System Impact Assessment Report

Thierry Mine Development

CAA ID 2008-309

Applicant: Richview Resources Inc

FIGURE 1 : CONNECTION ARRANGEMENT

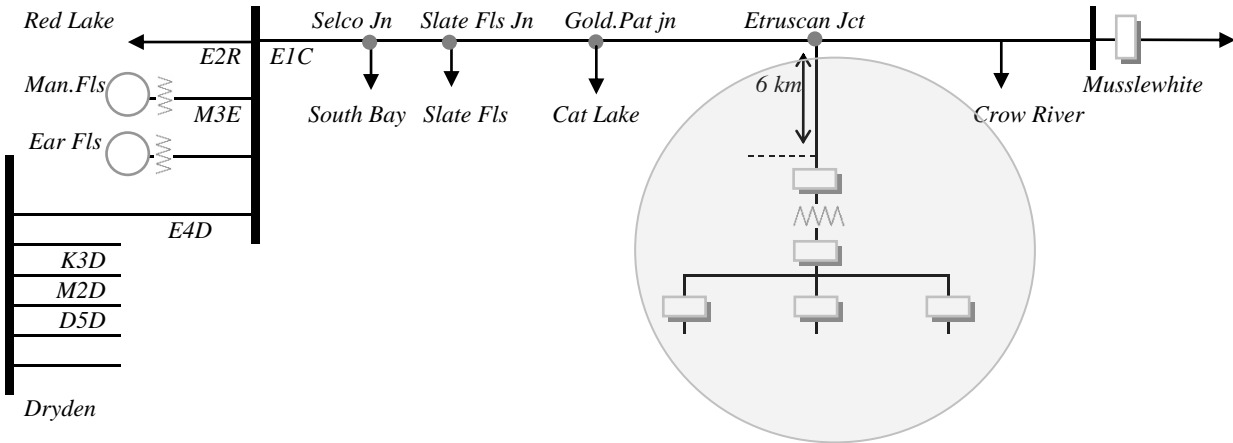
It is estimated that the peak mine load will be 9 MW. There are several motors in the mine, the largest being four induction motor water pumps which could be as large as 450 HP each and operated simultaneously. The power factor of the mine at 4.16 kV bus will be determined predominantly by the performance of induction motors. The starting of the motors could be staggered, but the starting of the last pump with other site load operating at peak would be the worst case.

(3) A supplementary reactive power supply will have to be provided at the mine site connected to the 4.16 kV bus. This must consist of a 15 MVar shunt capacitor bank with suitable steps and a +12/-8 MVar SVC. The above mentioned L/R scheme will also have to perform automatic load rejection at the mine in the event of loss of the capacitor bank and/or the SVC.

(4) Starting of 450 HP induction motors will have to be staggered to reduce transient voltage sag. To that end, the 450 HP induction motors must have interlocking so as to avoid their simultaneous starting.

FIG 4A : FOR C1

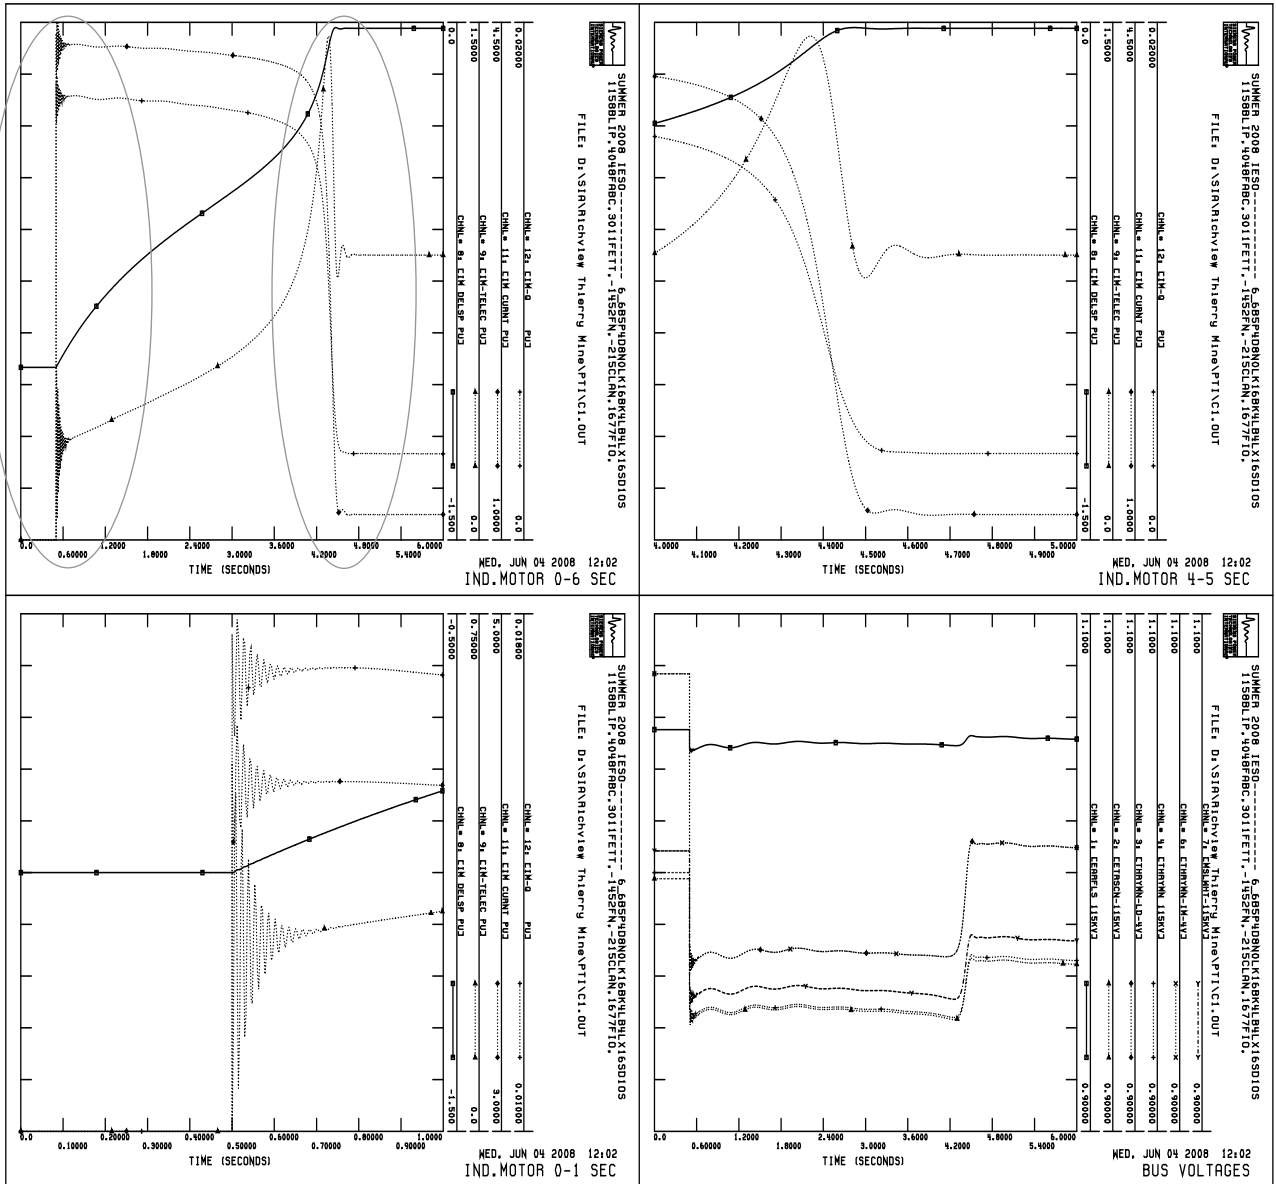
The motor is started at 0.5 sec of the simulation. The rotors exhibit oscillations with frequency of 60 Hz while drawing current of 4.4 times of nominal current and excessively high reactive power which cause the voltage to drop by 10.6 % at Thierry Mine 4 kV, 5.6 % at Etruscan and Thierry Mine 115 kV and 0.8 % at Ear Falls 115 kV. While the voltage remains low, the rotor torque increases resulting in rapid acceleration towards full speed. At this point the current and reactive power remains almost unchanged until the rotor reaches full speed before which the current and reactive power sharply drops and the

torque passes the pullout point. The entire process is completed within about 4 sec from the energizing. Then, the voltages recover back to acceptable levels, but still slightly below the pre-motor-start levels.

FIG 4B : FOR C2

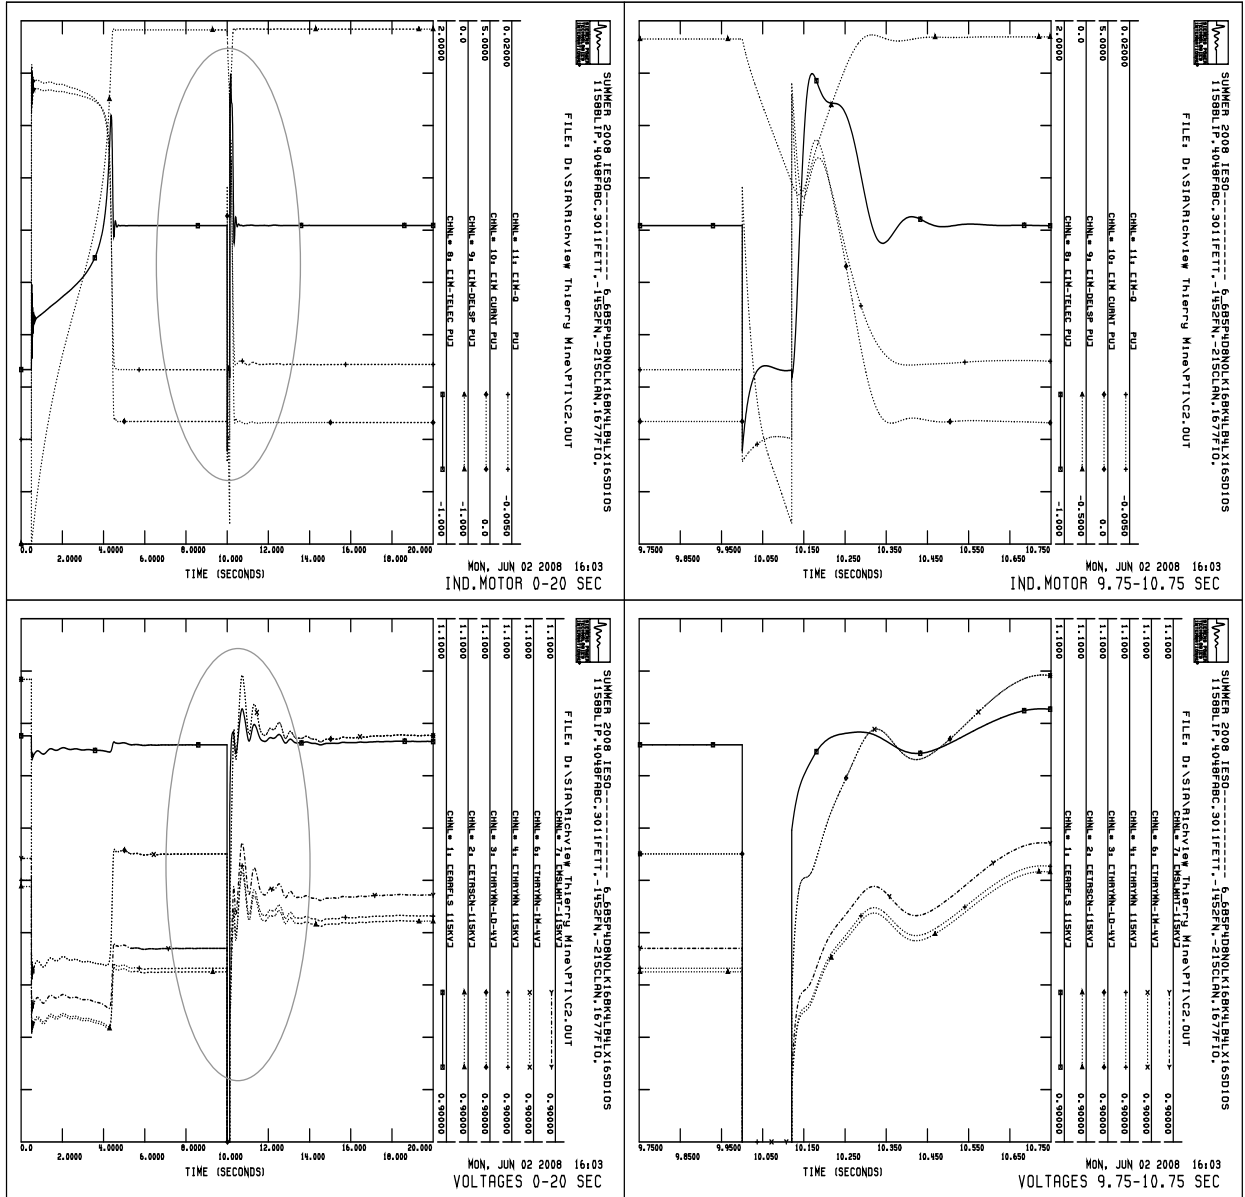
At the time of the contingency, as a result of reduced terminal voltage, the torque sharply drops and the rotors slow down. Once the fault is cleared, the motors recover back to their full speed without significant oscillations. The post-contingency voltages show the power system can recover back to an acceptable steady state after the contingency and the dynamics of motors do not contribute adversely to post-fault recovery.

Both simulations show that there is no evidence of adverse impact on the IESO-controlled grid either by the start of one of the induction motors in the mine or the behavior of the motor due to any other disturbance in the power system.
